Preamp Power Supply

Logic Control Circuit

David L. Huffman

August 23, 2000

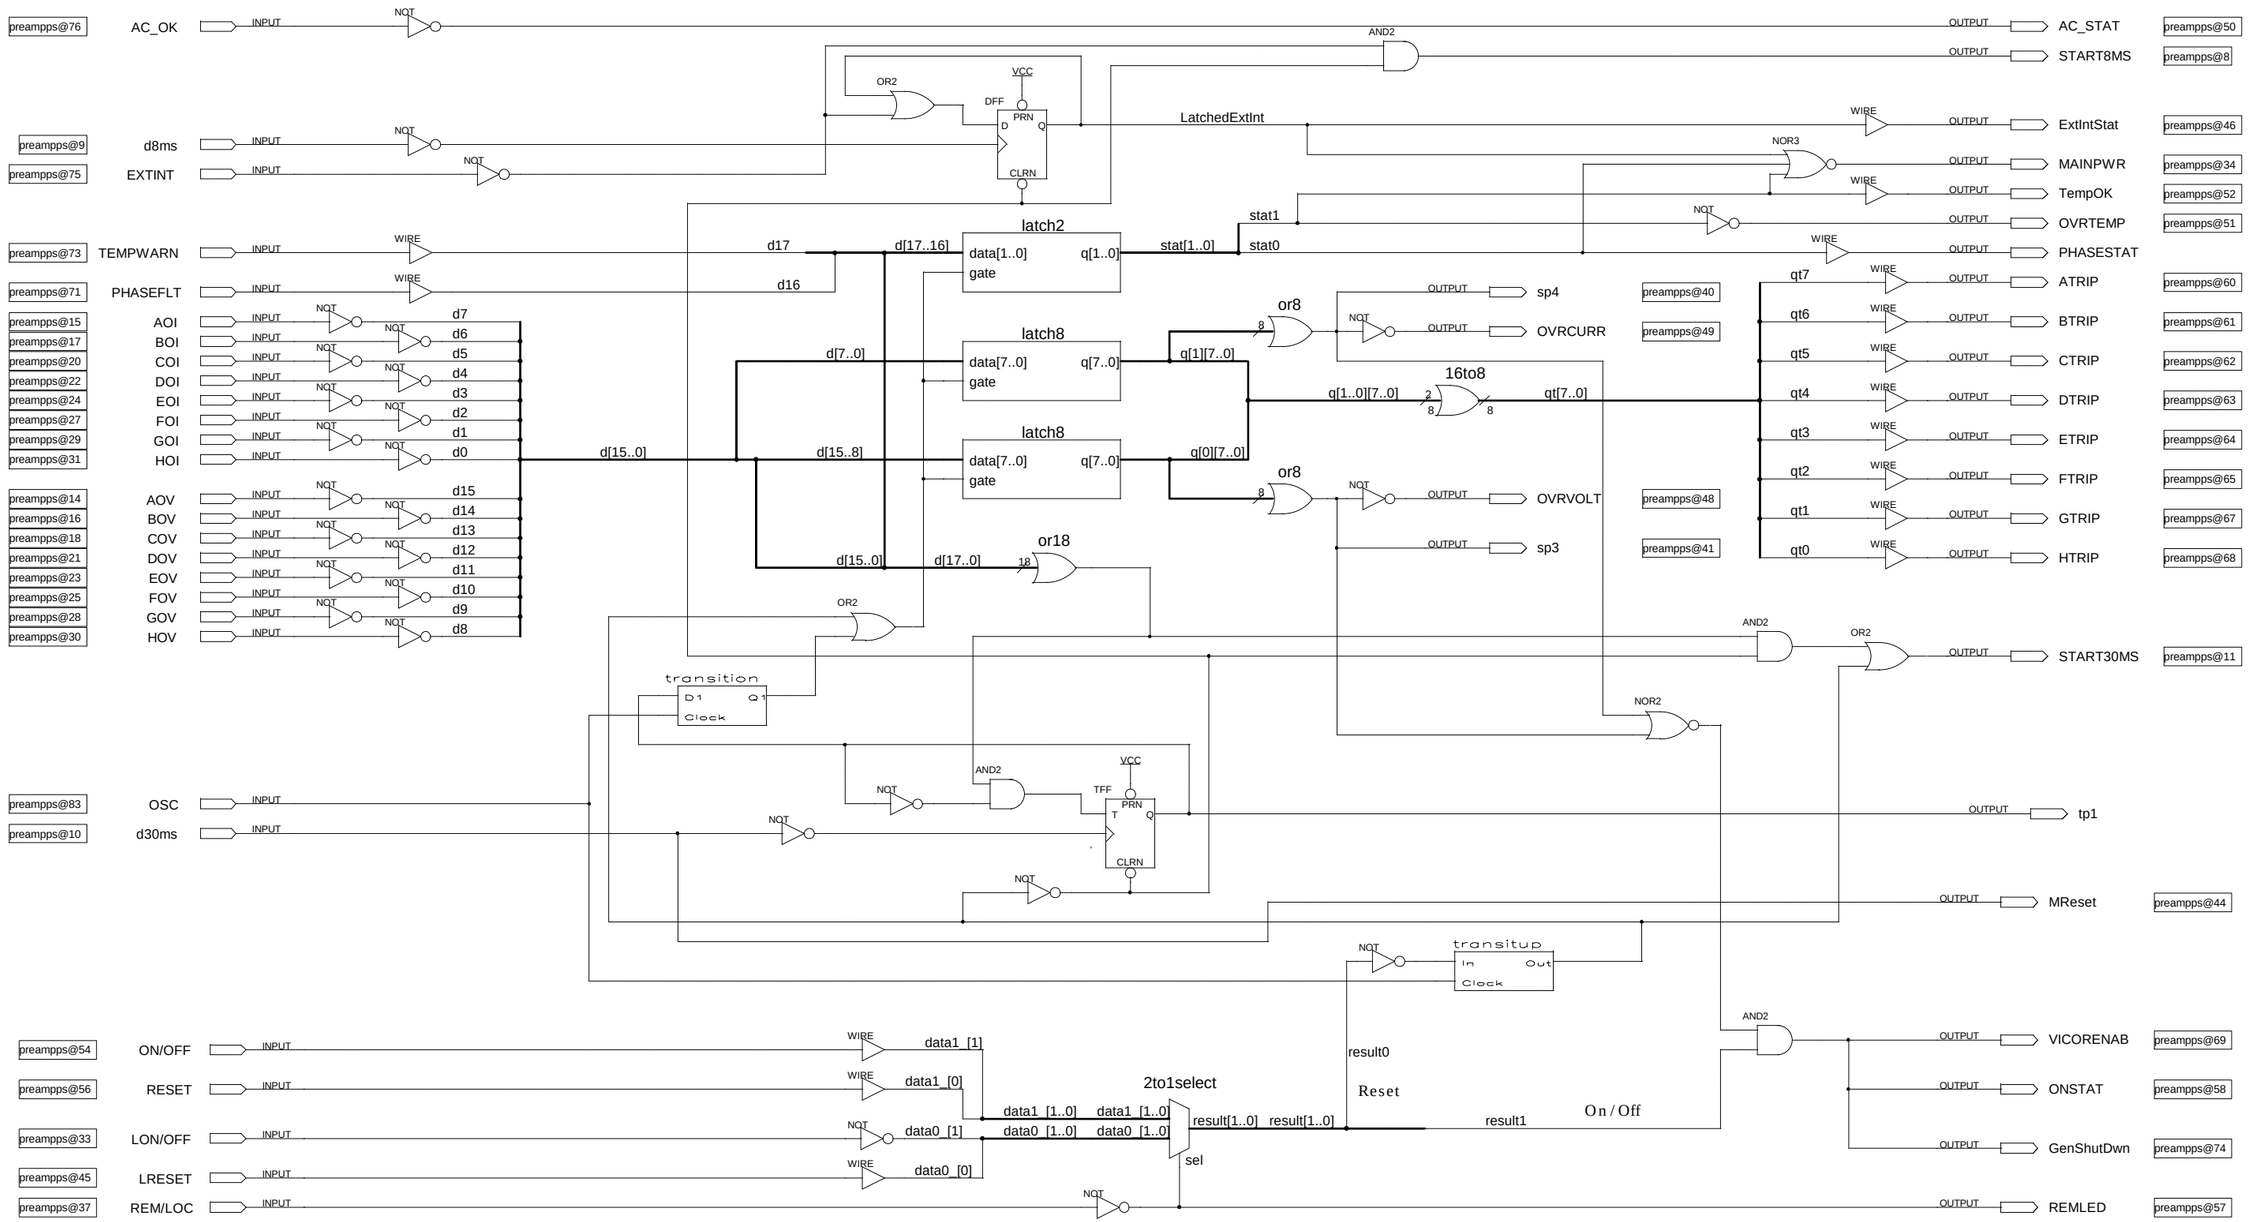
Changed External Interlock to trip under any condition.
Changed External Interlock to ignore signals <10ms in length.
Changed MReset to use one-shot output so reset LED shows.
ANDed the Overtemp & PhaseFault with the MainPwr output.
